David Lloyd Leisure Ltd

Reading

RE: TRANSPORT RESPONSE NOTE

Date: 19 May 2026
Application: 253130

Figure 2-1: Existing Vs Proposed Carriageway

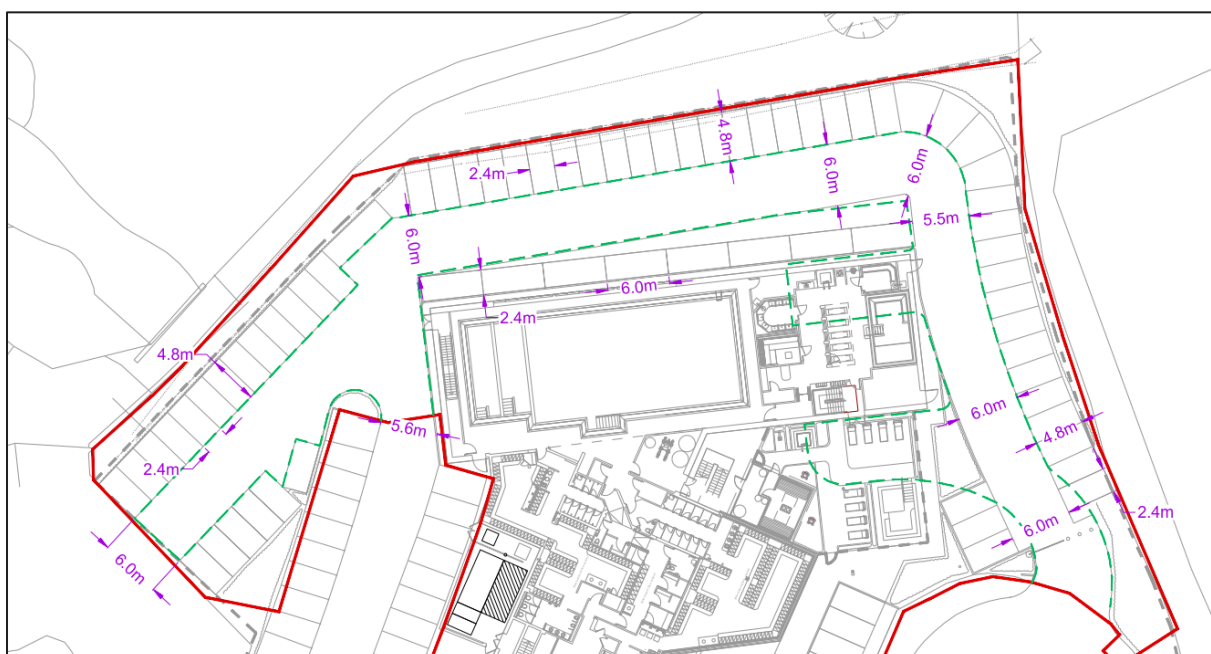
The parking indicated on the proposed site plan is not consistent with the number of spaces outlined in the Transport Assessment. Given the application relies on the shared parking, the applicant should provide a revised plan which aligns with the Transport Assessment.

- 2.1 WBC have requested a clarification on the discrepancy between the parking numbers detailed in the proposed site layout drawing (Appendix B of Transport Assessment, Appendix A of Travel Plan and Delivery and Servicing Management Plan) and the parking numbers used for assessment within the Transport Assessment.
- 2.2 The proposed site layout drawing provided in the aforementioned appendices are an earlier iteration which has been superseded. For the avoidance of doubt, all tracking plans and assessments contained within the Transport Assessment and other supporting reports (Travel Plan and Delivery and Servicing Management Plan) and hereafter are based on the current and correct version. The current and correct version is provided at **Appendix B**.

- 2.3 The development proposal is an extension to the existing site. The access routing through the site for delivery and servicing vehicles remains the same as existing and as such the servicing of the site is the same as existing.
- 2.4 Notwithstanding this, tracking plans are provided, however the site is already serviced appropriately. This is not a new development; it is an existing site and the road network within the site remains largely unchanged. An outline of the existing carriageway at the site (marked in green) in relation to proposed layout is shown in **Figure 2-1**. A full drawing is provided at **Appendix C**.

Figure 2-2: Refuse Vehicle

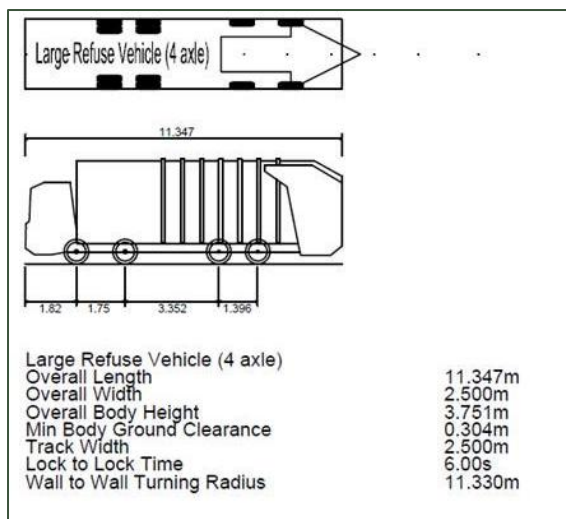
The applicant has demonstrated the manoeuvring of a refuse collection vehicle (ref: PD01_AT01). However, the refuse vehicle used is an inadequate size. The applicant should provide an updated drawing using the refuse vehicle below. The vehicle tracking also illustrates the refuse vehicle entering the David Lloyd car park passing through a bollard. The entrance barrier will need to be widened in order to accommodate the refuse vehicle.

- 2.7 Updated refuse vehicle tracking is provided at **Appendix D**. A larger refuse vehicle has been tracked as per the vehicle specification shown in **Figure 2-2** and this shows the vehicle being able to access the site without moving a bollard.
- 2.8 For context this is how a refuse vehicle would access the site currently. There is no change to the existing situation.

Figure 2-3: Fire Tender

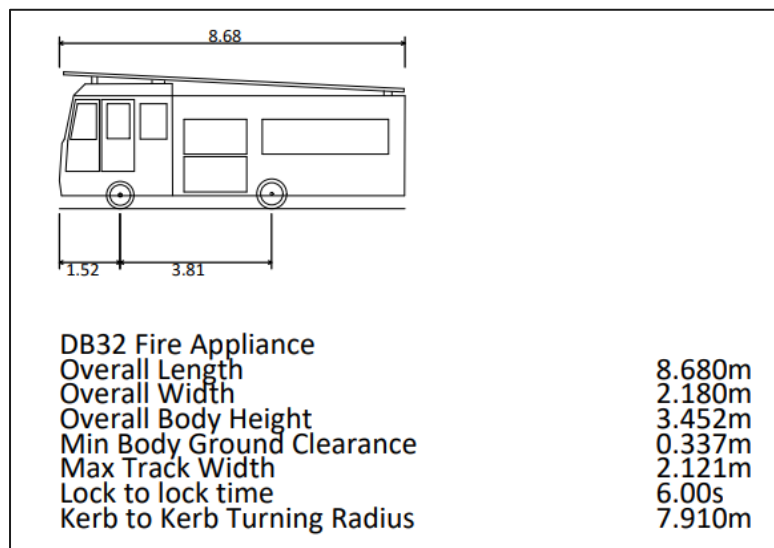
The current fire tender swept path analysis shows overrun of the access bollards. The access will require widening to enable fire tender access. Updated plans should be provided that show a widened access and acceptable swept path analyses.

The applicant has demonstrated the manoeuvring of a fire tender vehicle (ref: PD01_AT03). However, the fire tender used is an inadequate size. The applicant should provide an updated drawing using the fire tender below. The vehicle tracking also illustrates the fire tender entering the David Lloyd car park entrance passing through a bollard. The entrance barrier will need to be widened in order to accommodate the fire tender.

- 2.9 Updated fire tender tracking is shown in Drawing PD01_AT04 provided at **Appendix E**. A larger fire tender has been tracked as per the vehicle specification shown in **Figure 2-3**. This no longer impacts on the bollards. This is how a fire tender would access the site currently in emergency situations. There is no change to the existing situation.

Figure 2-4: Service Vehicle

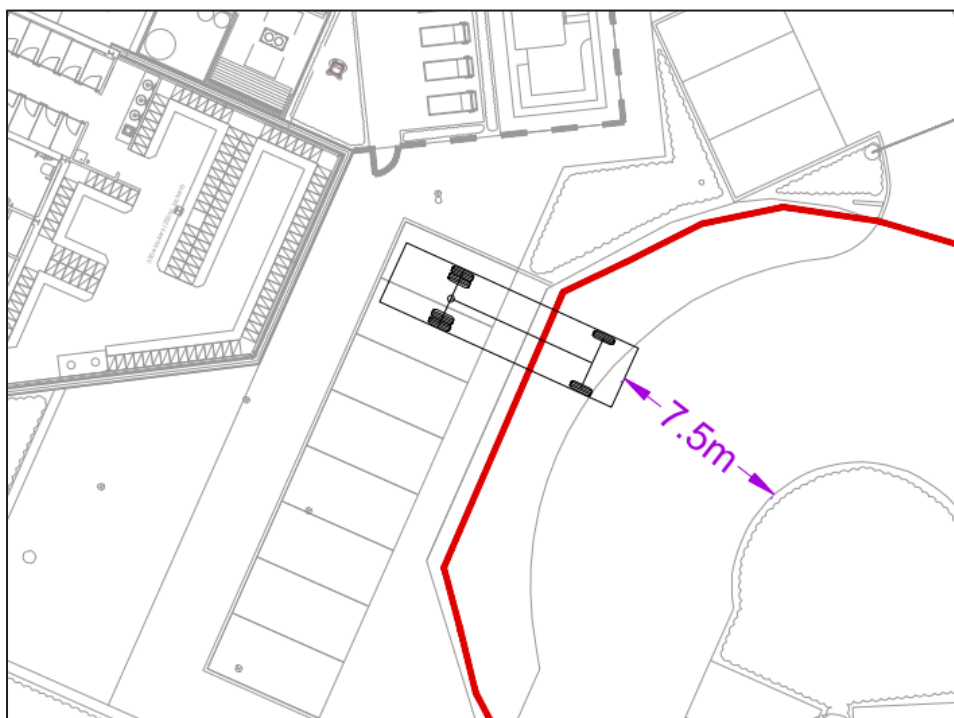
The applicant has indicated the dedicated servicing area on the western side of the main building, which will be accessed by servicing vehicles outside of opening hours. The applicant has also stated that during business hours, deliveries can be received at the front of the building. However, from the plans provided (ref: PD01_AT02.1) it is unclear where these deliveries will take place without obstructing the one-way car park or pedestrian access. This will need to be clarified on a plan.

- 2.11 WBC has queried whether the service vehicle parked up adjacent to building entrance can take place without obstructing the one-way car park or pedestrian access. **Figure 2-4** shows a snippet from the tracking work submitted as part of the planning submission which clearly shows that the vehicle does not obstruct the one-way car park or interfere with the pedestrian access. The pedestrian route is shown in yellow.

Figure 4-1: Location of EV Charging Bays

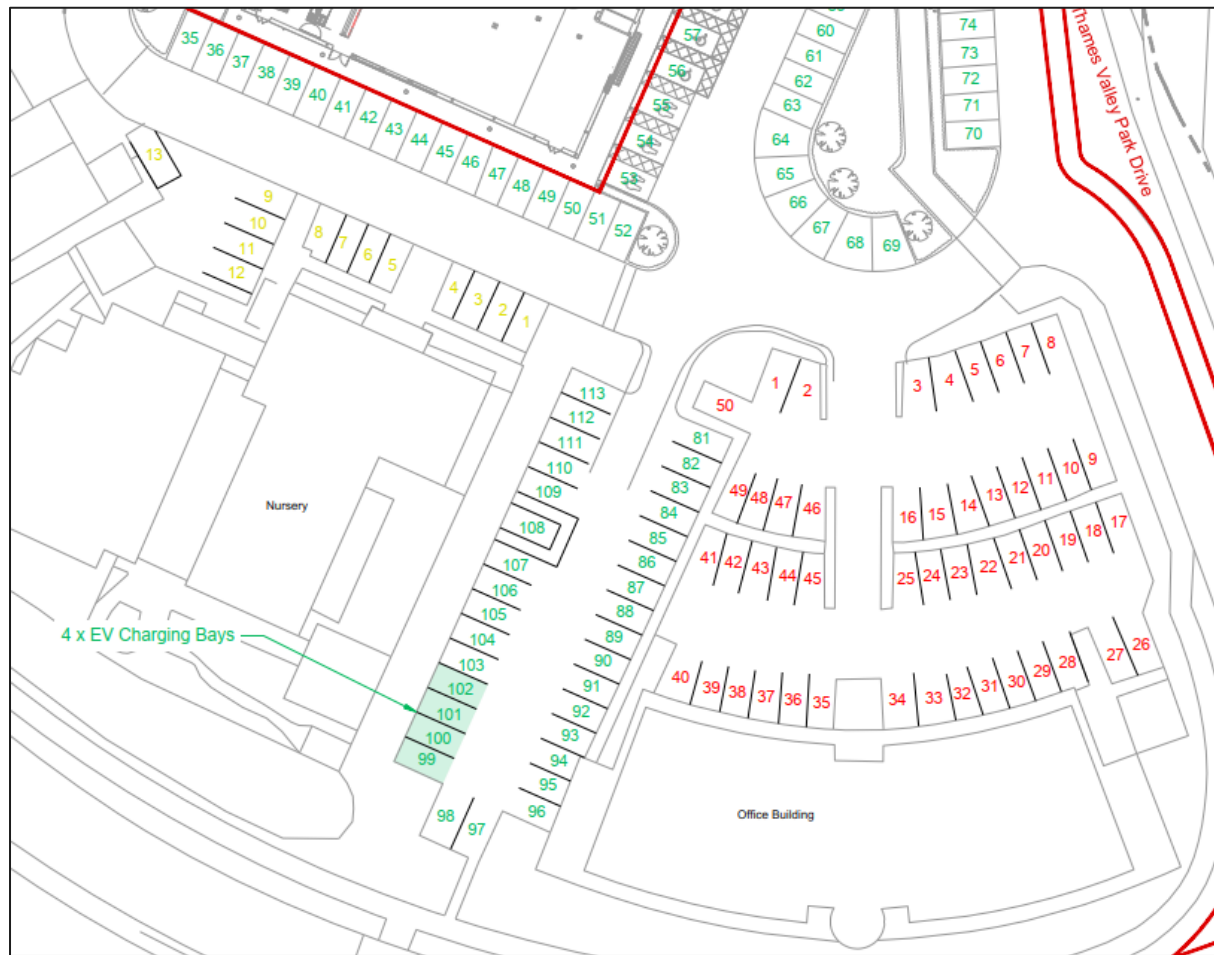
The Applicant has stated that 4 EV charging points will be provided in the shared parking area. Highways would welcome plans that indicate the locations of these as well as the location of cable routes.

- 4.1 WBC has requested details in relation to the Electric Vehicle (EV) charging provision at the site.
- 4.2 The Transport Assessment confirms there are 4 EV charging bays provided within the shared parking area. The locations of these bays are shown in **Figure 4-1**. Full drawing is provided at **Appendix G**.
